STATE OF MAINE
DEPARTMENT OF TRANSPORTATION
16 STATE HOUSE STATION
AUGUSTA, MAINE
04333-0016

September 18, 2008
Subject: **Minot**
Federal Project No. 16572.00
State Pin No. 016572.00
Amendment No. 1

ROUTE 119

MINOT, MAINE

Sheet No.:	CT4	of	CT7
------------	-----	----	-----

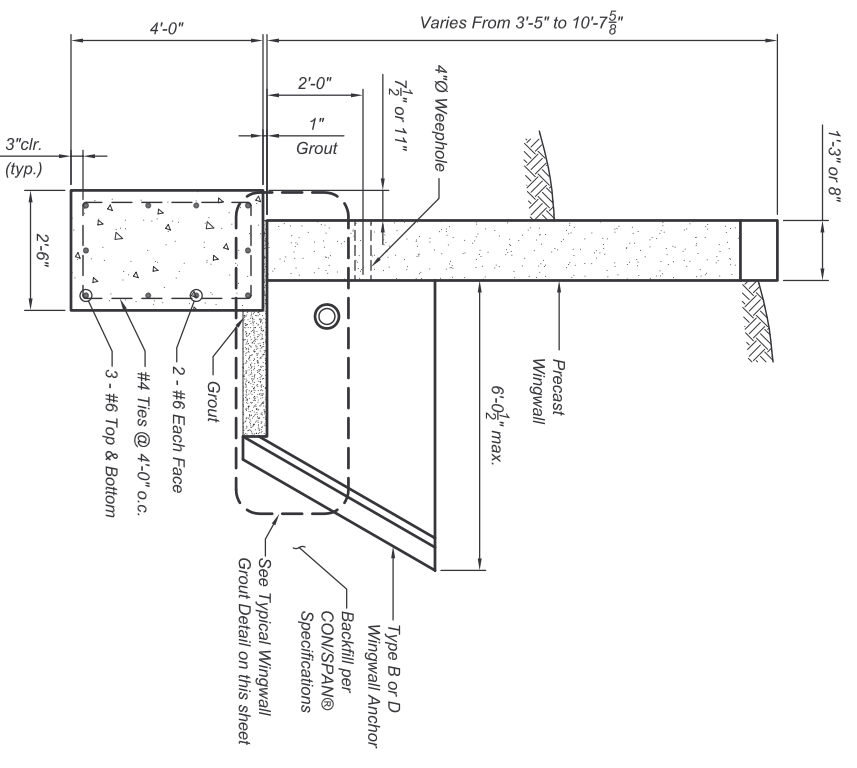
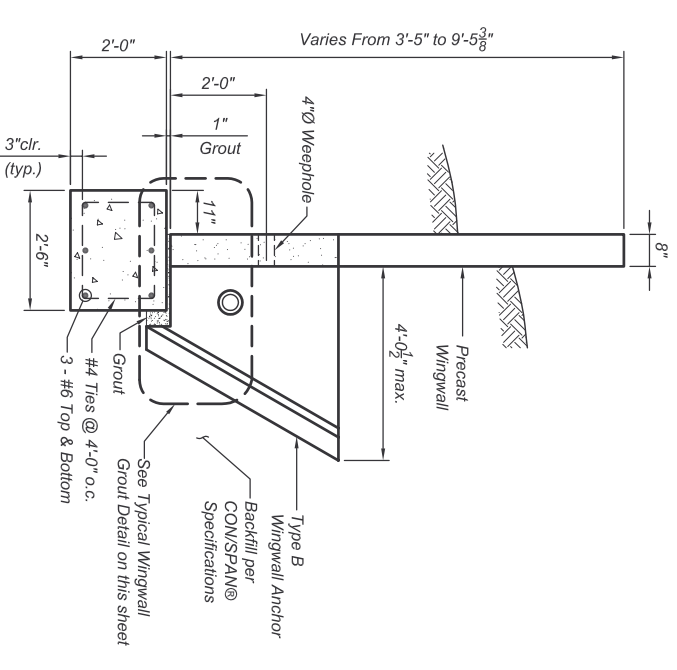
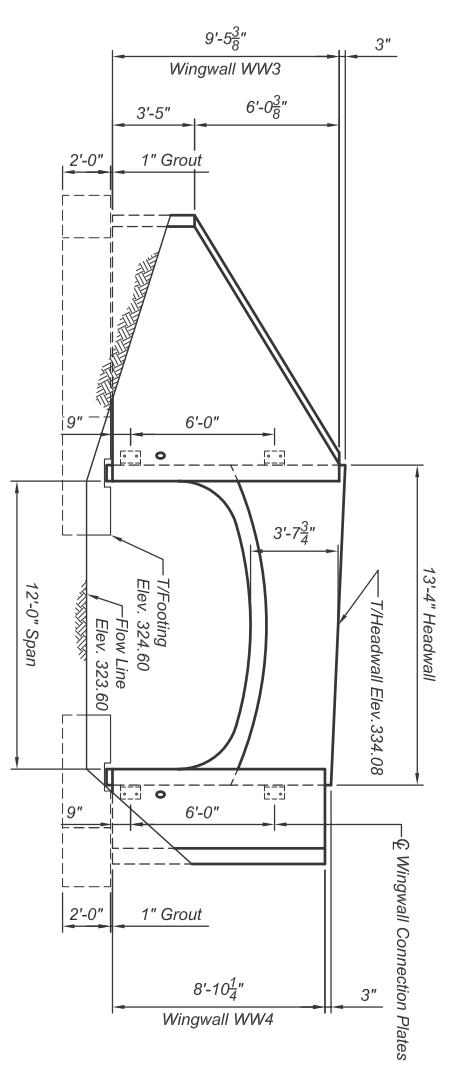
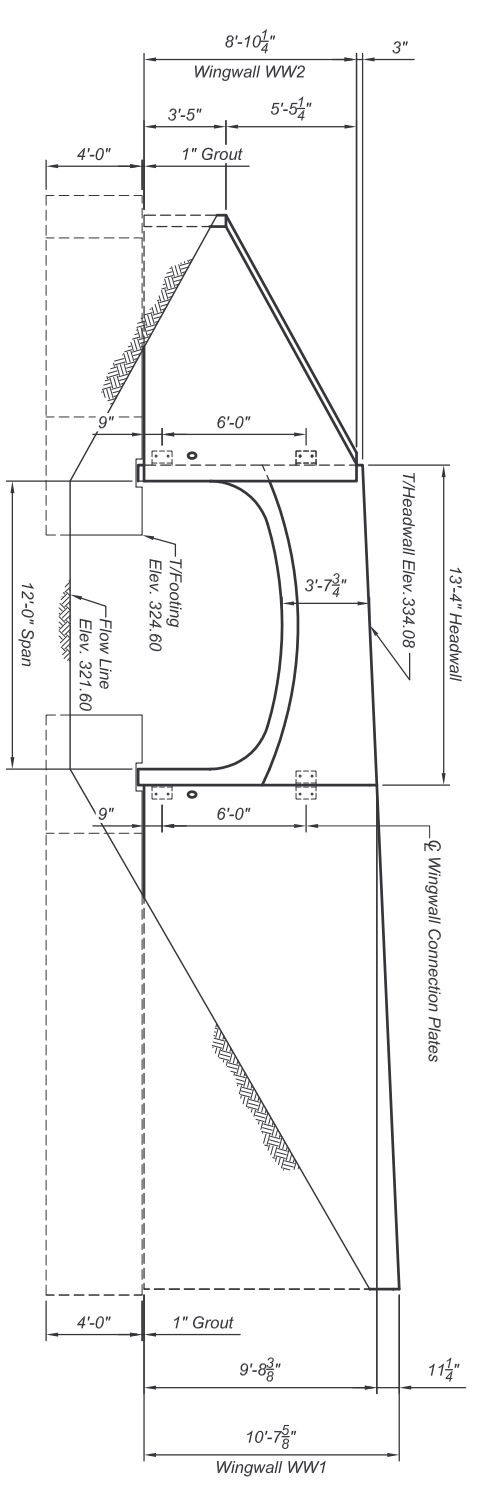
Question: The spacing of the #4 Ties on Detail 2-CT3 of sheet CT3 are 1'-0" O.C. and the spacing of the #4 Ties on Details C & D on sheet CT4 are 4'-0" O.C., which is correct.

Response: Both spacing's are correct on the plans as shown. The 4' O.C. spacing on sheet CT4 is for the wings only.
